DESCRIPTION:
CIRCUIT DIAGRAM
MR2, ADM3,
SCR FRAME MODULE

DRAWING NO. OSK-12435

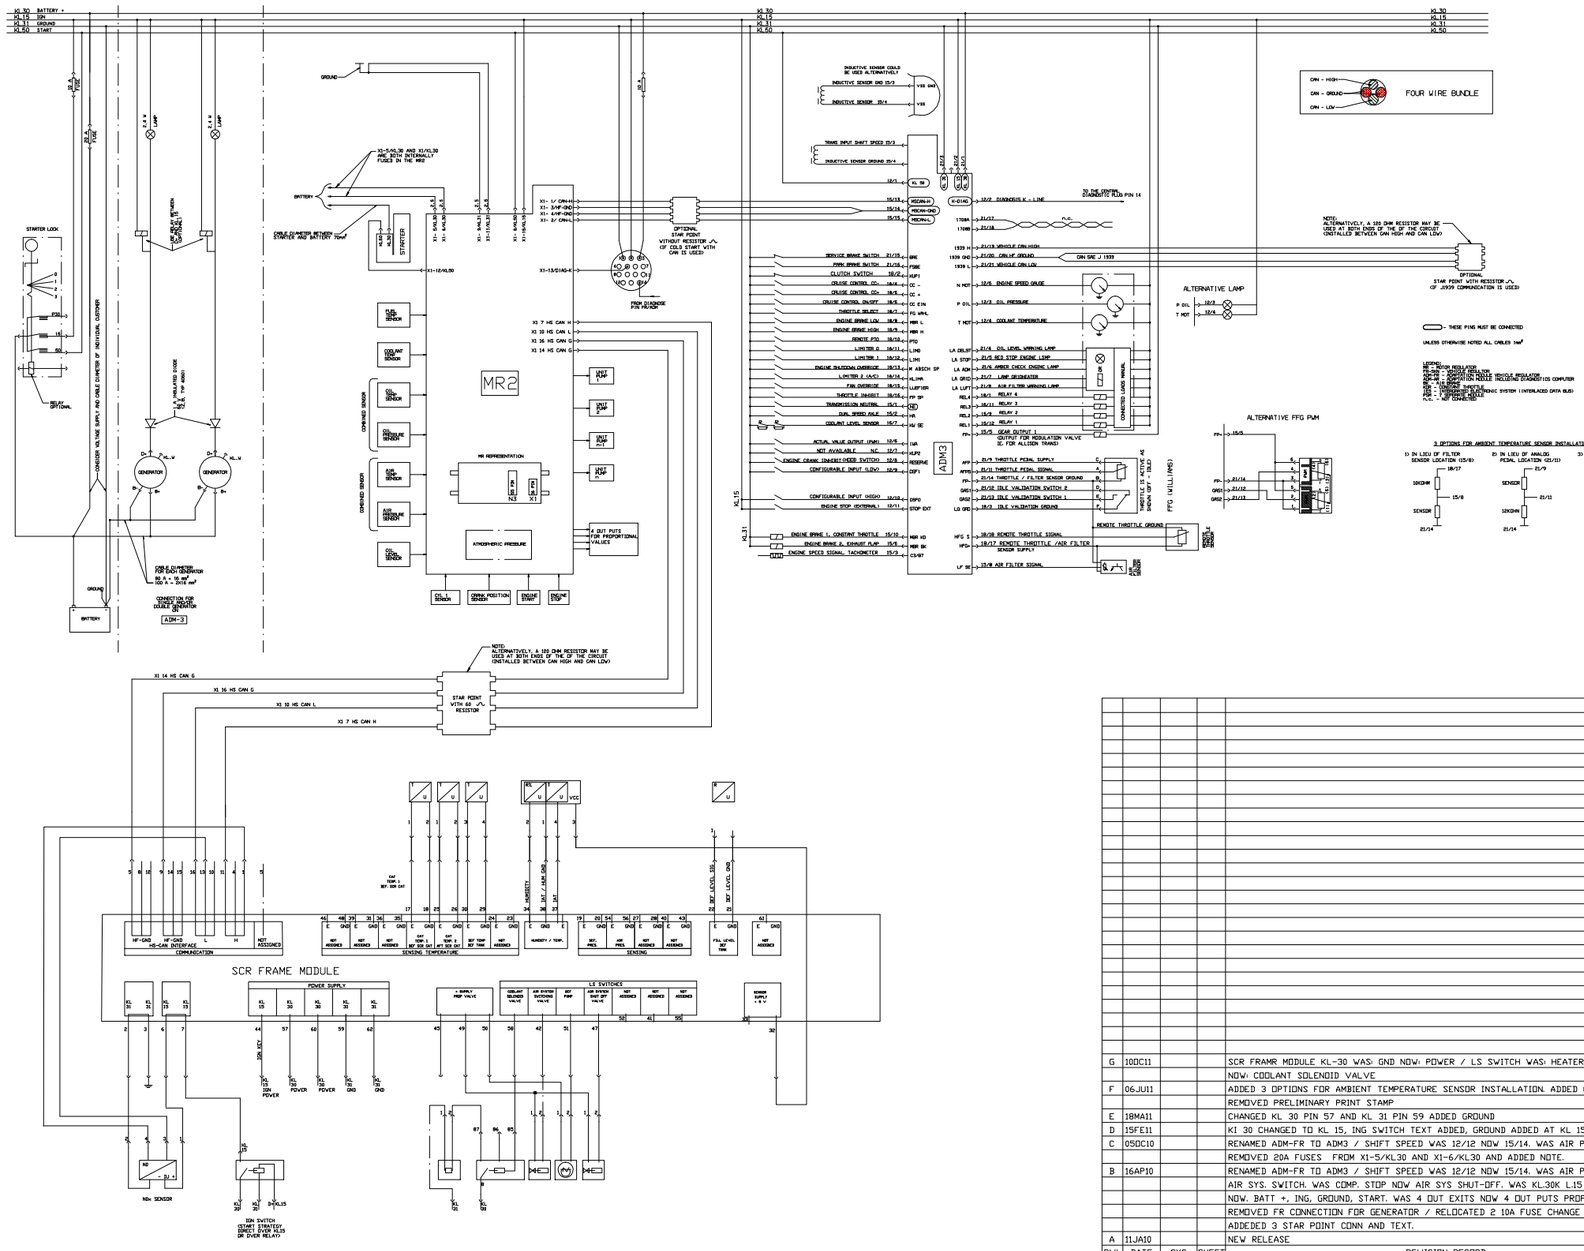
G	10DC11			SCR FRAMR MODULE KL-30 WAS: GND NOW: POWER / LS SWITCH WAS: HEATER ICF LINE	WS	DW
				NOW: COOLANT SOLENOID VALVE		
F	06JU11			ADDED 3 OPTIONS FOR AMBIENT TEMPERATURE SENSOR INSTALLATION. ADDED CIM DRAWING #	WS	DW
				REMOVED PRELIMINARY PRINT STAMP		
E	18MA11			CHANGED KL 30 PIN 57 AND KL 31 PIN 59 ADDED GROUND	WS	DW
D	15FE11			KI 30 CHANGED TO KL 15, ING SWITCH TEXT ADDED, GROUND ADDED AT KL 15	WS	DW
C	05DC10			RENAMED ADM-FR TO ADM3 / SHIFT SPEED WAS 12/12 NOW 15/14. WAS AIR PSI. VALUE NOW	WS	DW
				REMOVED 20A FUSES FROM X1-5/KL30 AND X1-6/KL30 AND ADDED NOTE.		
B	16AP10			RENAMED ADM-FR TO ADM3 / SHIFT SPEED WAS 12/12 NOW 15/14. WAS AIR PSI. VALUE NOW	WS	DW
				AIR SYS. SWITCH. WAS COMP. STOP NOW AIR SYS SHUT-OFF. WAS KL.30K L.15 KL.31KL.50		
				NOW. BATT +, ING, GROUND, START. WAS 4 OUT EXITS NOW 4 OUT PUTS PROP		
				REMOVED FR CONNECTION FOR GENERATOR / RELOCATED 2 10A FUSE CHANGE ONE TO 20A

ADDEDED 3 STAR POINT CONN AND TEXT.		
A	11JA10			NEW RELEASE	WS	DW
RVL	DATE	SYS	SHEET	REVISION RECORD	DR	CHK
